<p>James C. Porter, Director County Government Center 555 County Center, 5th Floor - Redwood City, CA 94063 www.smcgov.org</p>	ADDENDUM NO. 2
	Project No. P30J1 Grant Yard Radio Shop Project Redwood City, CA
	Issue Date: January 11, 2021

This Addendum No. 2, dated January 11, 2021, includes the following:

L113
ATTACHMENT 1

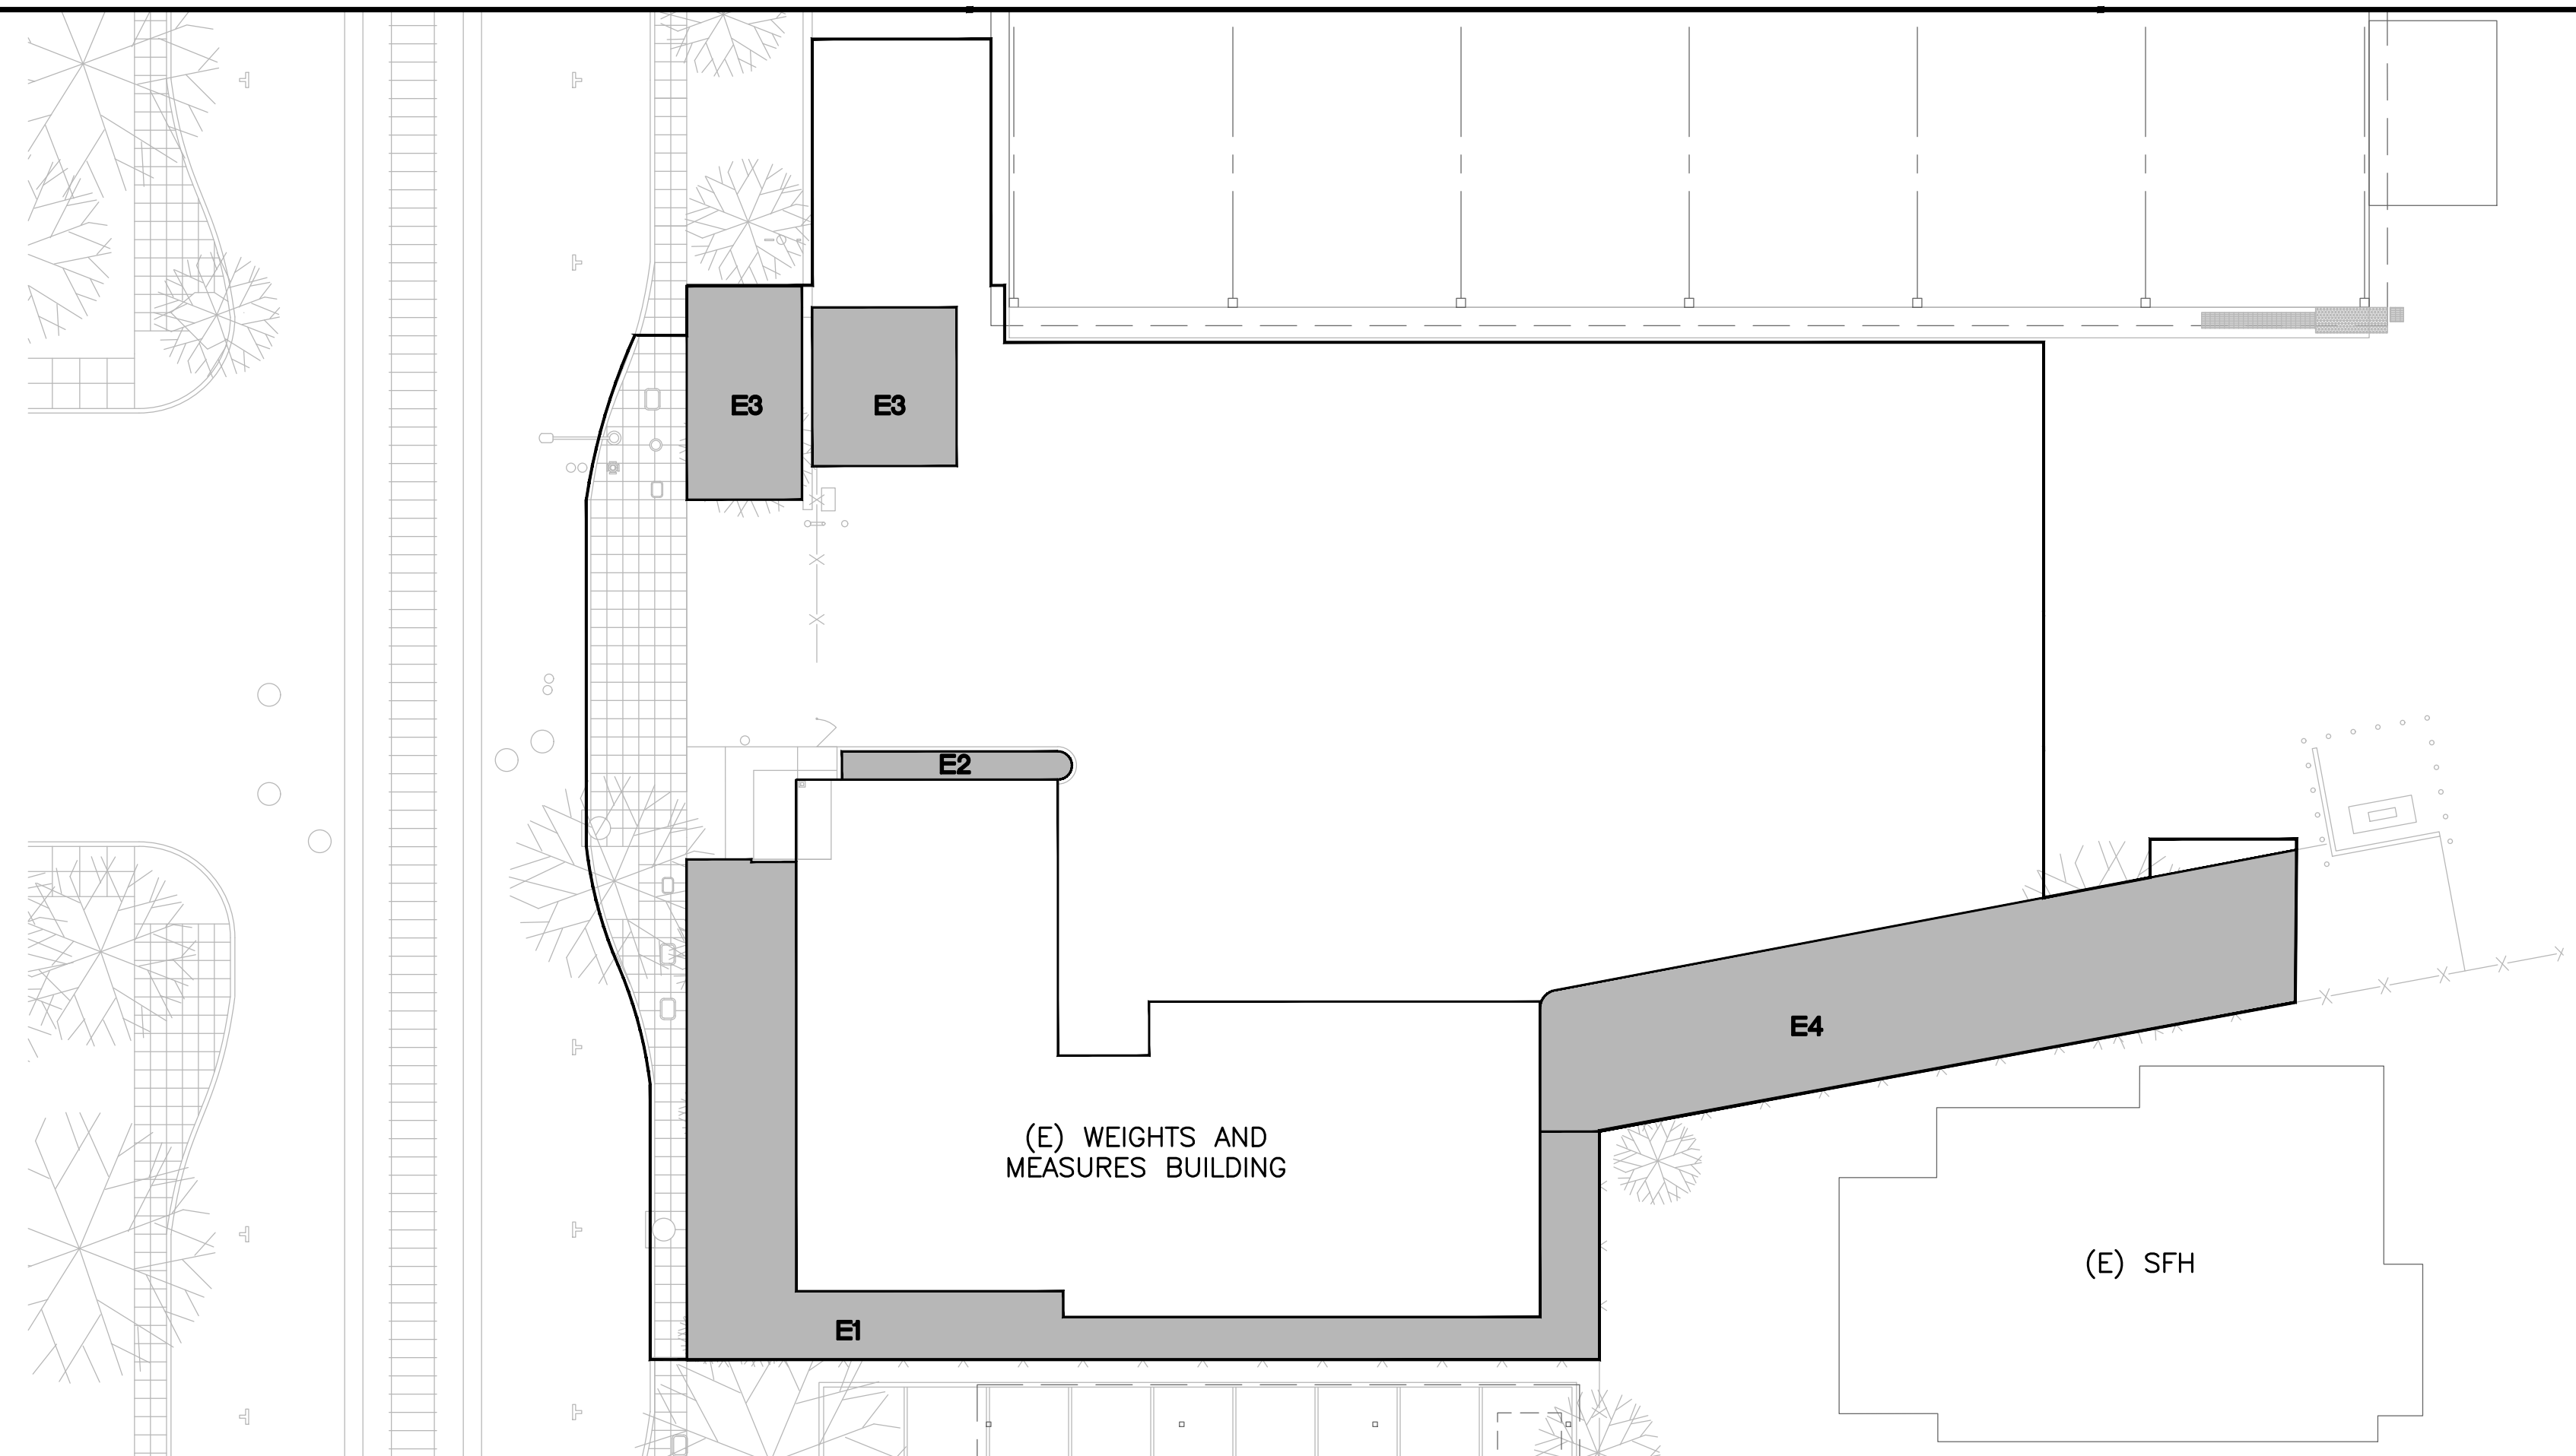
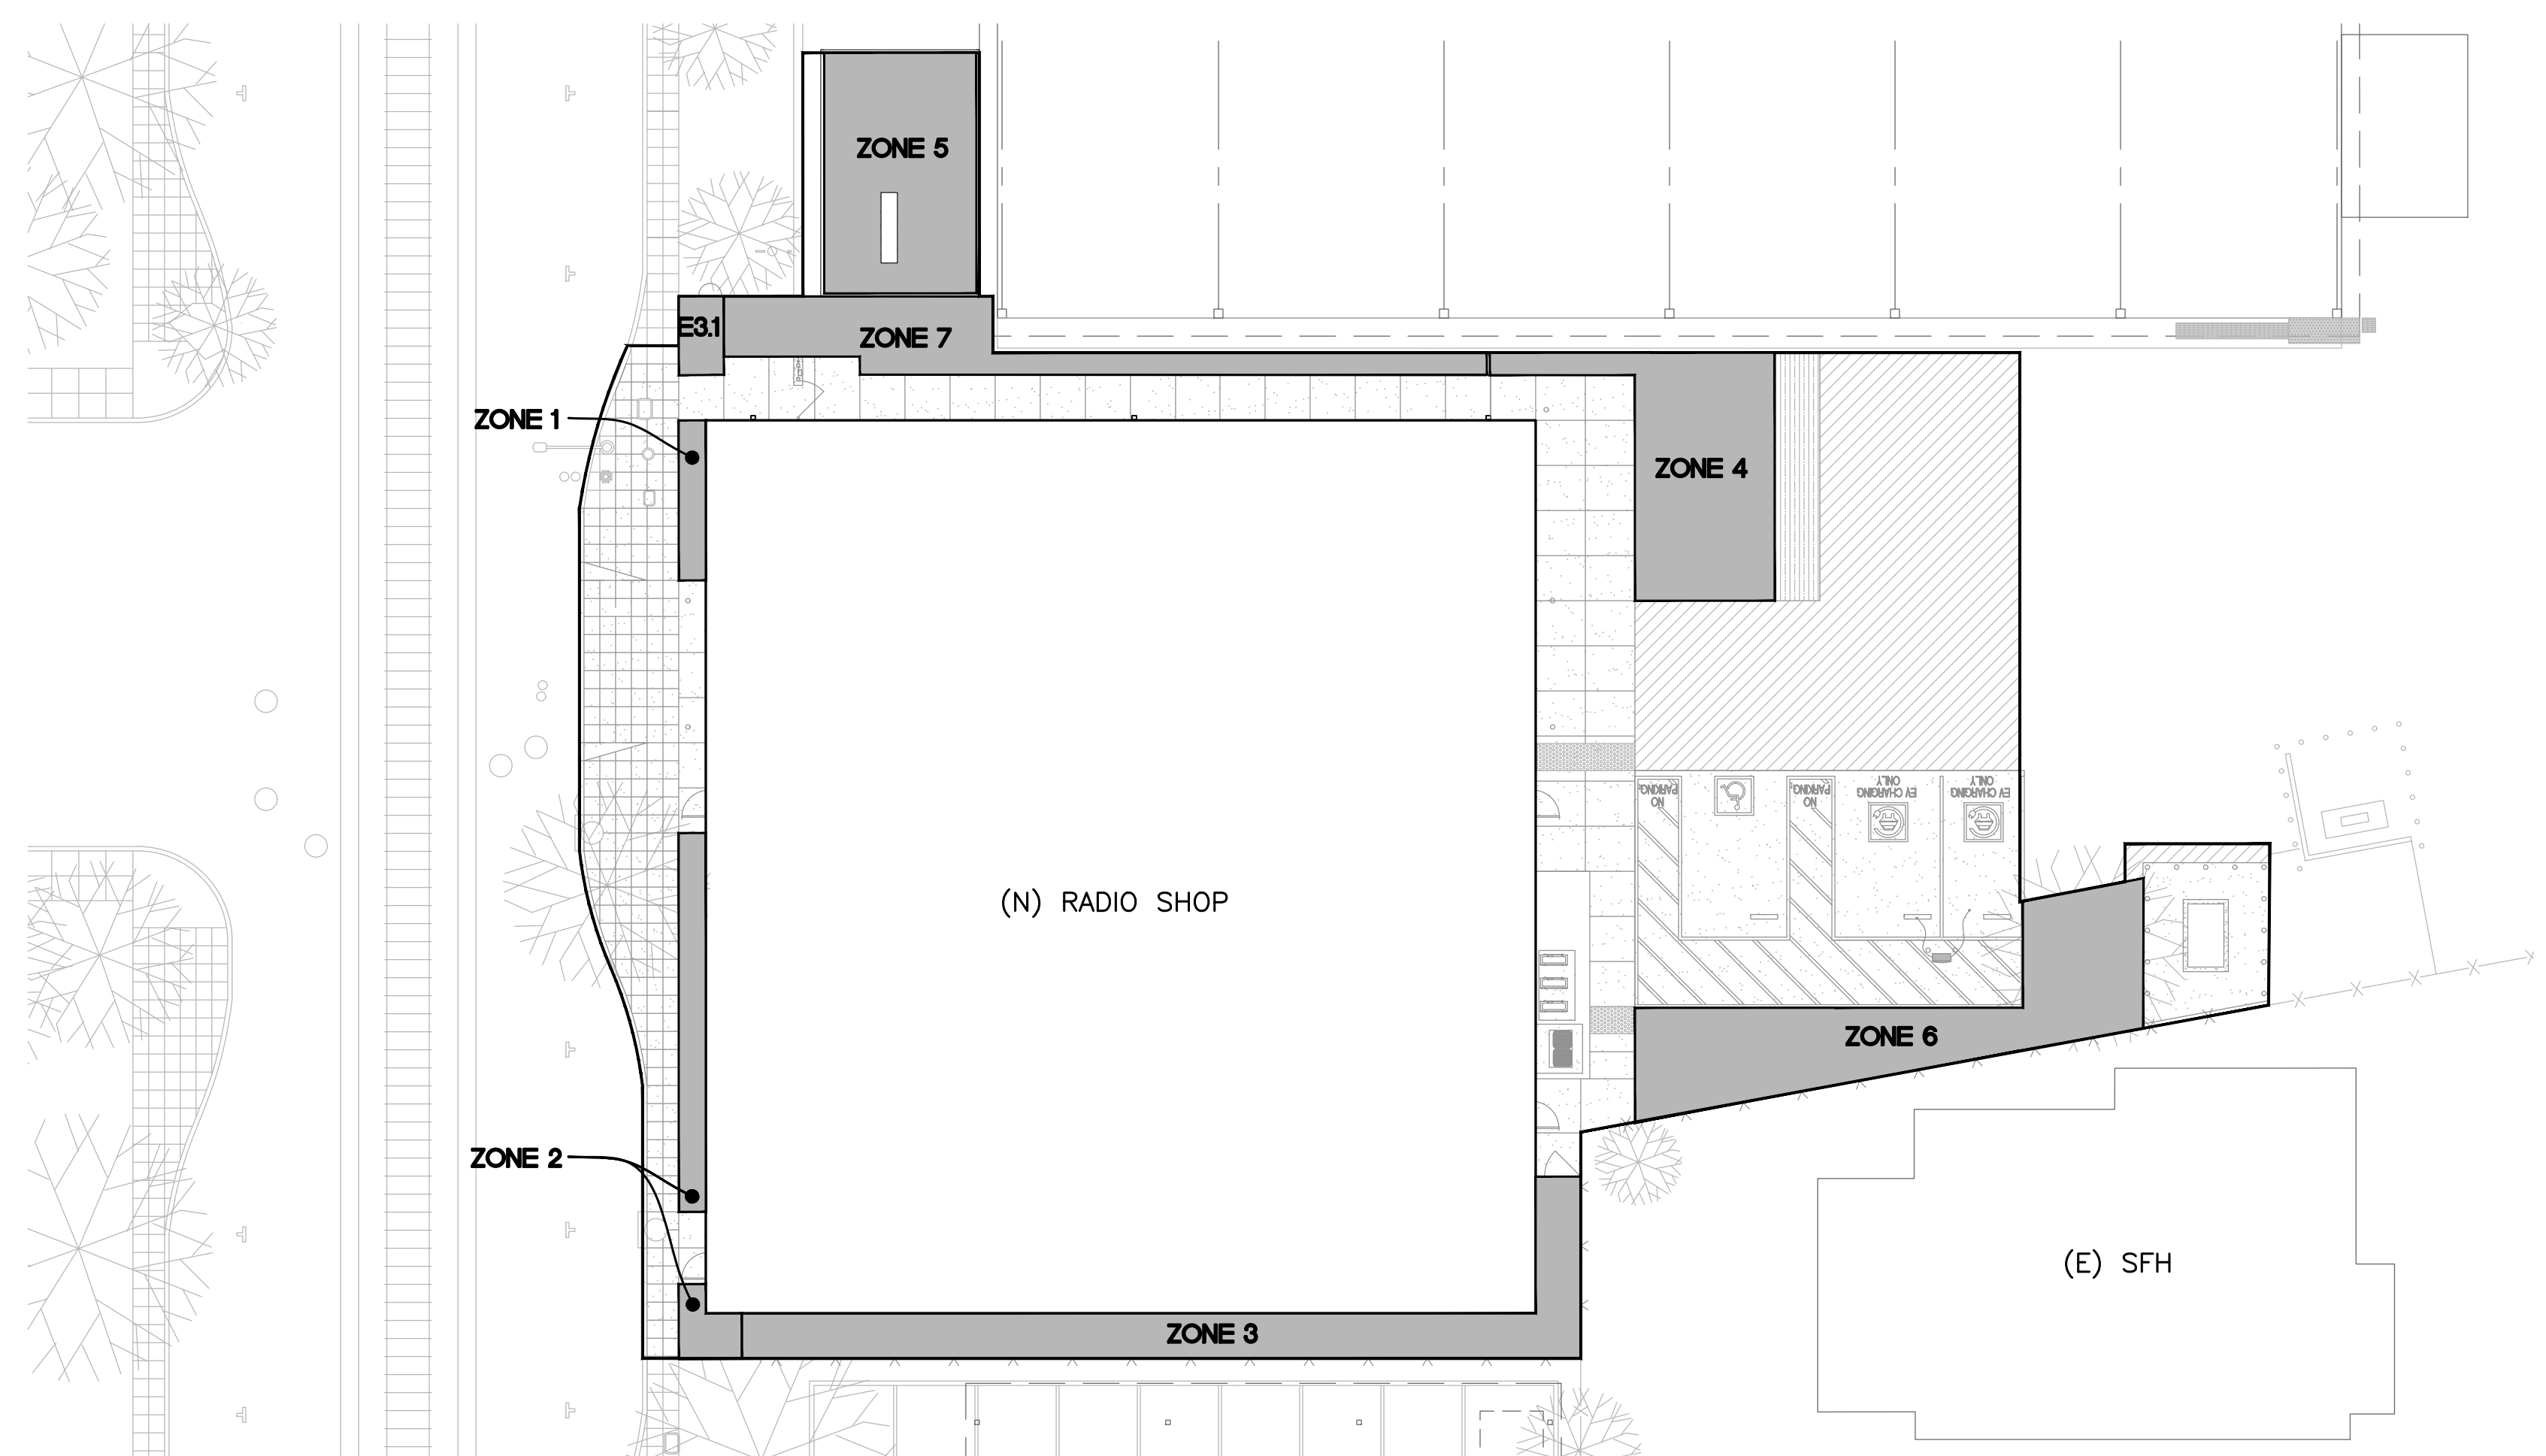
- I. Modifications or Clarifications to the Contract Documents & Contracting Requirements (Drawings, Specifications, Project Manual)**
 - A. Drawing L113 -Stormwater calculations revised, no impact on site design. See Attachment 1.
 - B. Drawing C505, Note 1 - Cleanouts at underdrain PVC piping shown in site plan. view. North biofiltration basin, north infiltration trench and east biofiltration area. See Attachment2.
 - C. Drawing C505, Note 1, 8, and 13 - Cleanout, perforated underdrain, overflow drain inlet, solid PCV drain pipe to manhole shown in plan for clarity at north biofiltration basin. See Attachment2.
 - D. Drawing C505, Notes 1, 8, 13 and 14 - Added for clarity and piping extended at east biofiltration area (Note 11). See Attachment2.
 - E. Drawing C505, Note 14 -Underdrain solid 4" PVC drainage pipe connection distance of approx. 118'-0". See Attachment2.
